CITY PLANNING COMMISSION

- APPLICATION:
1. Environmental Determination
 2. Rezone two existing corner lots from Single Family (R-1) to Townhouse (R-1A) zone
 3. Tentative Map to divide one corner lot (Lot 1196) into two parcels for halfplex development
 4. Special Permit for halfplex development on Lot 1196

APPLIC. NO. P83-190

TENTATIVE MAP for
 RESUBDIVISION of LOT 1196 of
GREENHAVEN UNIT NO. 11 (104 BM 1)
 CITY OF SACRAMENTO, CALIFORNIA
 MAY 1983 SCALE: 1" = 20'
 MURRAY SMITH AND ASSOCIATES

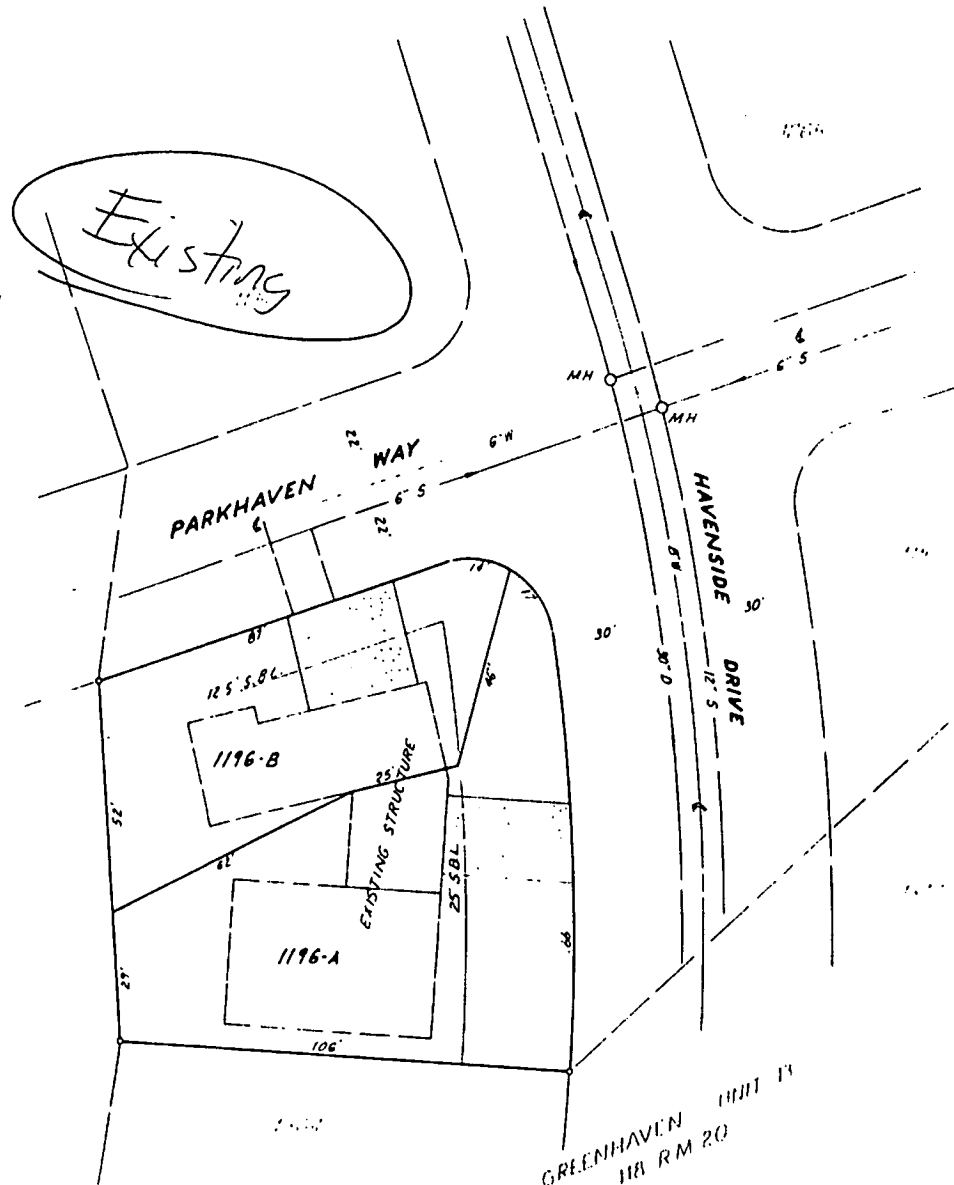
Provide separate water and sewer services to each lot and hookup to the existing system.

- a. Provide separate water and sewer services to each lot and hookup to the existing system;
- b. Pursuant to City Code Section 40.1302 (Parkland Dedication), the applicant shall submit to the City an appraisal of the property to be subdivided and pay the required parkland dedication in-lieu fees. The appraisal shall be dated not more than 90 days prior to the filing of the final map.

HALENSIDE ELEVATION

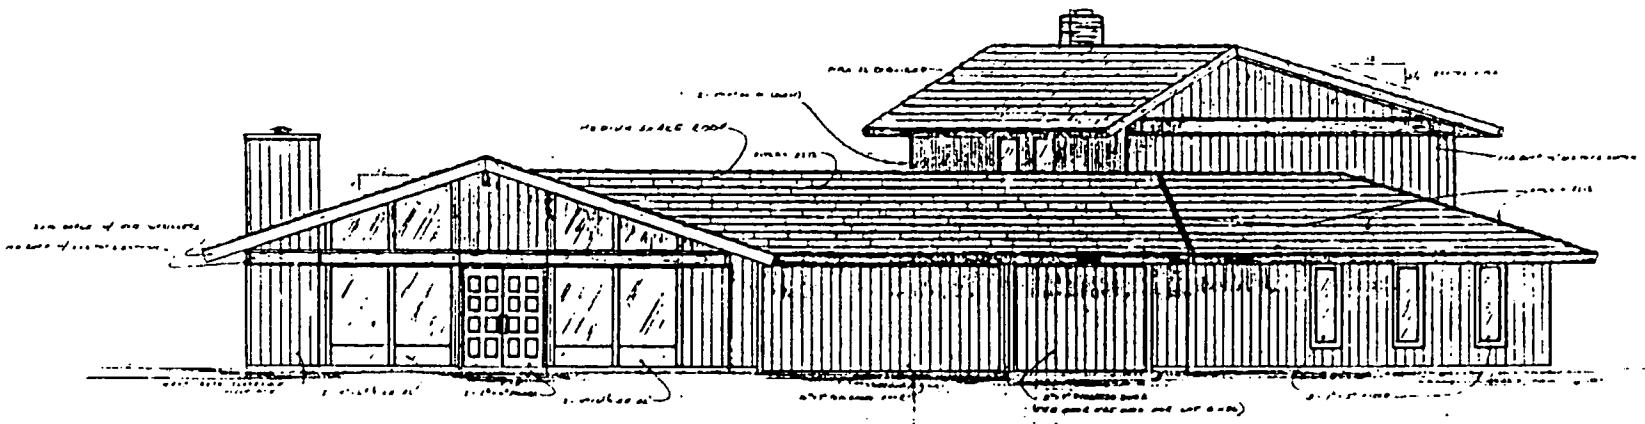
Shake roofing and varied exterior materials shall be used as shown on submitted elevations.
